ADDENDUM NO. 2

May 6, 2025

**Peru Jr./Sr. HS, Blair Pointe Upper ES, and Elmwood Primary Learning Center – Preventative Maintenance and Related Work
Peru, IN 46970**

ADDENDUM TWO

SHEET
E-300

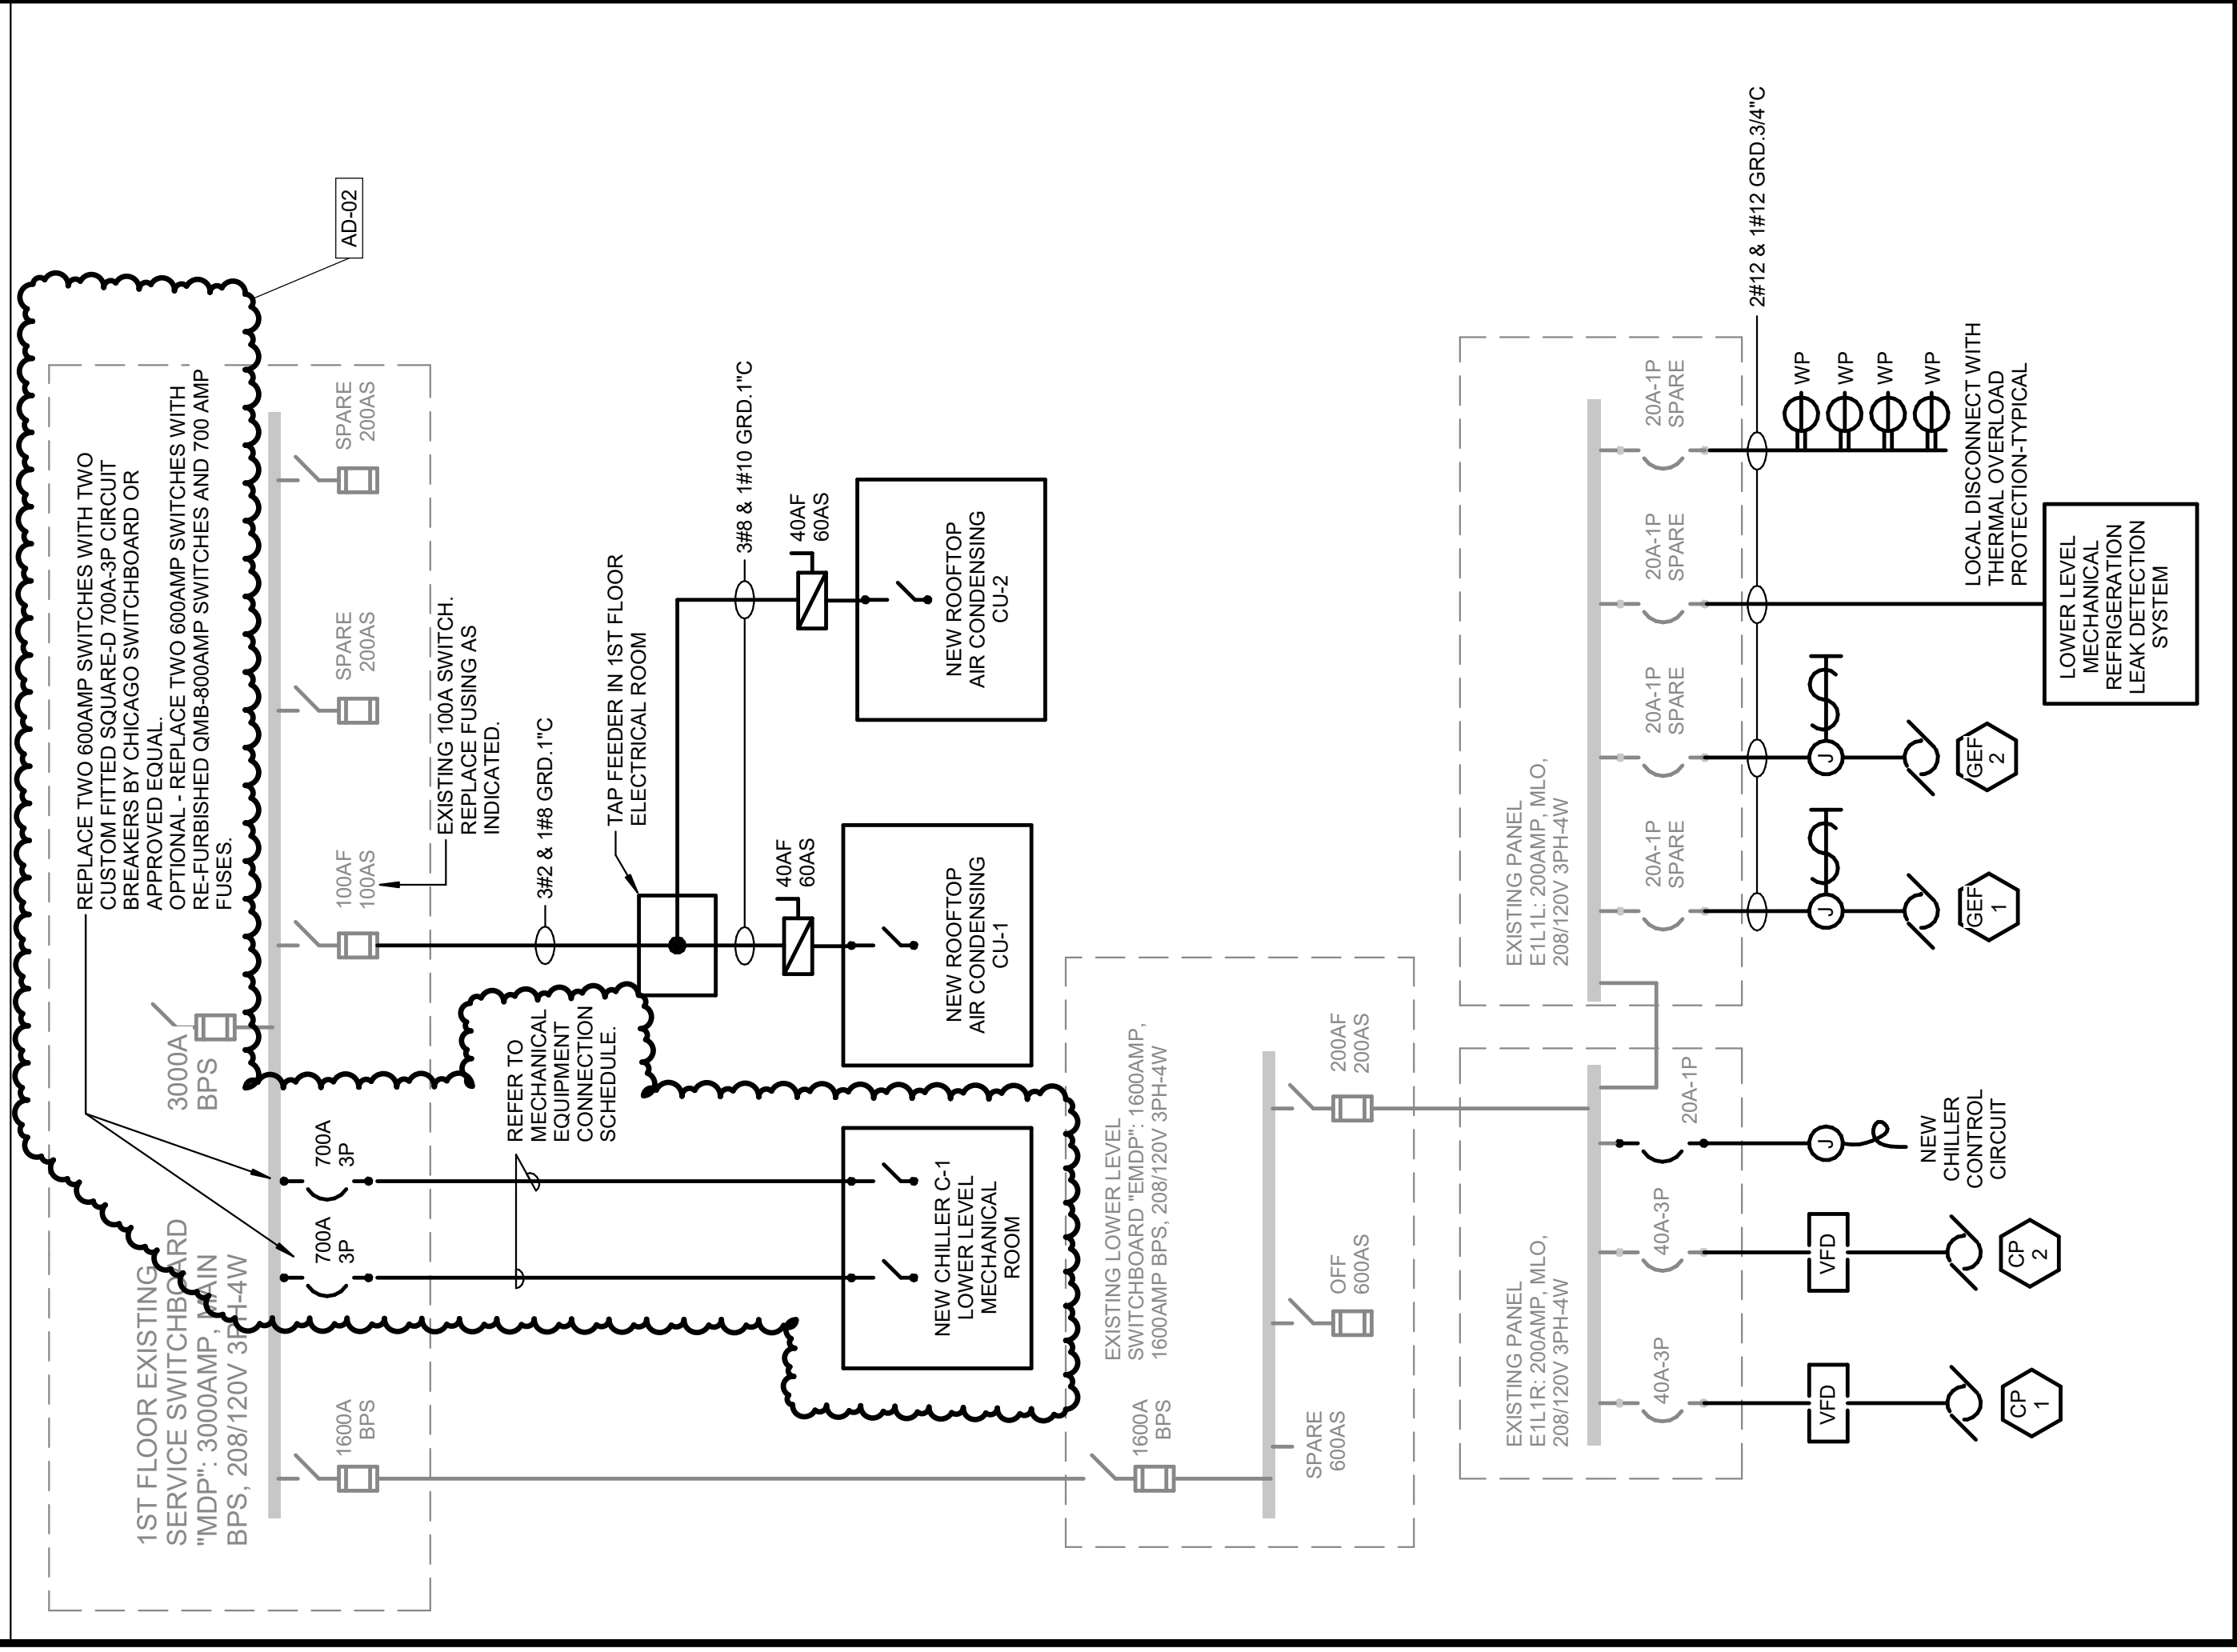
- A. See Addendum #1.
15. **Concerning Elmwood Primary LC Switchgear. Sheet E-300 ADD#1 One -line diagram Elmwood Primary, it is saying to replace fuses to 700A in existing 800 amp switch. This switchgear has no 800A switches in it. There are 2 – Existing 600A switches marked Chiller. Please advise on what direction to go.**

20. Sheet E-300**Electrical Details**

- A. Revised Chiller C-1 Electrical Requirements for Elmwood.

- A. See Addendum #2.
